**Economic and Social Council**Distr.: General  
7 August 2013

**Economic Commission for Europe****Inland Transport Committee****World Forum for Harmonization of Vehicle Regulations****Working Party on Lighting and Light-Signalling****Seventieth session**

**Regulation No. 48 (Installation of lighting and light-signalling devices) –****Proposal for amendments to the 06 series of amendments****Proposal for Supplement 3 to the 06 series of amendments to Regulation No. 48 (Installation of lighting and light-signalling devices)****Submitted by the expert from Poland\***

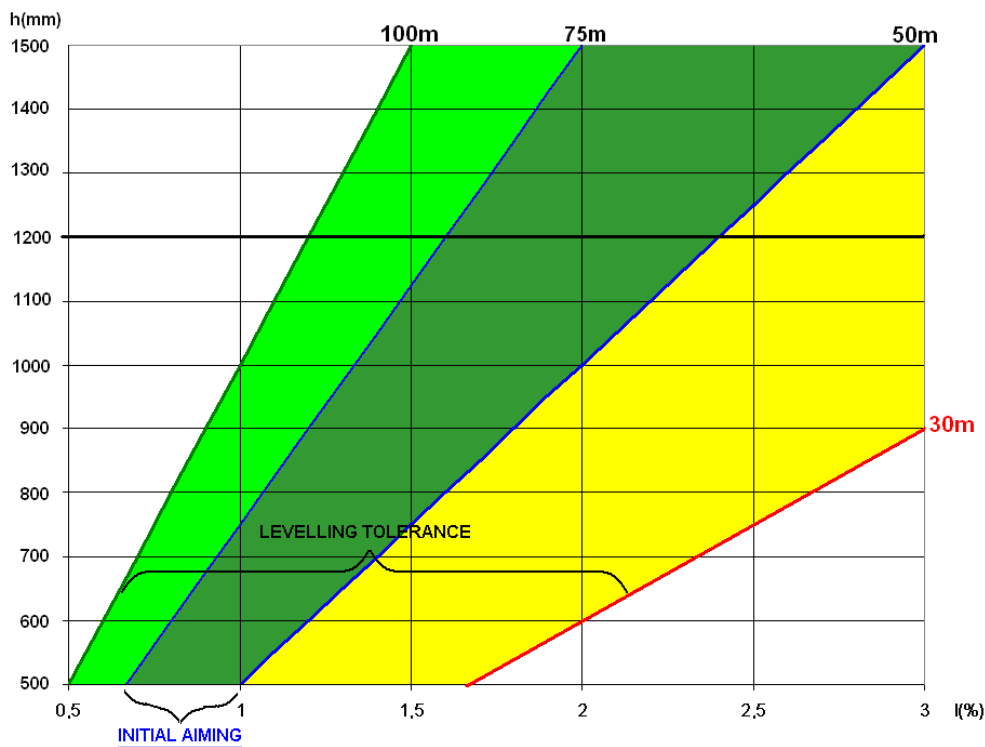
**"6.2.6.1.3. Depending on the mounting height in millimetres (h) of the dipped-beam headlamp reference axis, the vertical inclination of the cut-off of the dipped-beam (in the direction of the reference axis) measured on the unladen vehicles, taking in account 0.1 per cent accuracy, shall have the value of initial downward inclination (initial aiming) for which the horizontal part of the cut-off intersects with the surface of a flat horizontal road at a distance between 50 m and 75 m from the headlamp.**

**The aiming limits under all the static conditions of Annex 5 shall be such that the distance of intersection of the horizontal part of the cut-off with the road surface shall remain between 30 m and 100 m, including aiming inaccuracy (see figure below).**

**At the discretion of the manufacturer the minimum distance of intersection of the horizontal part of the cut-off with the road surface longer than 30m may be declared.**
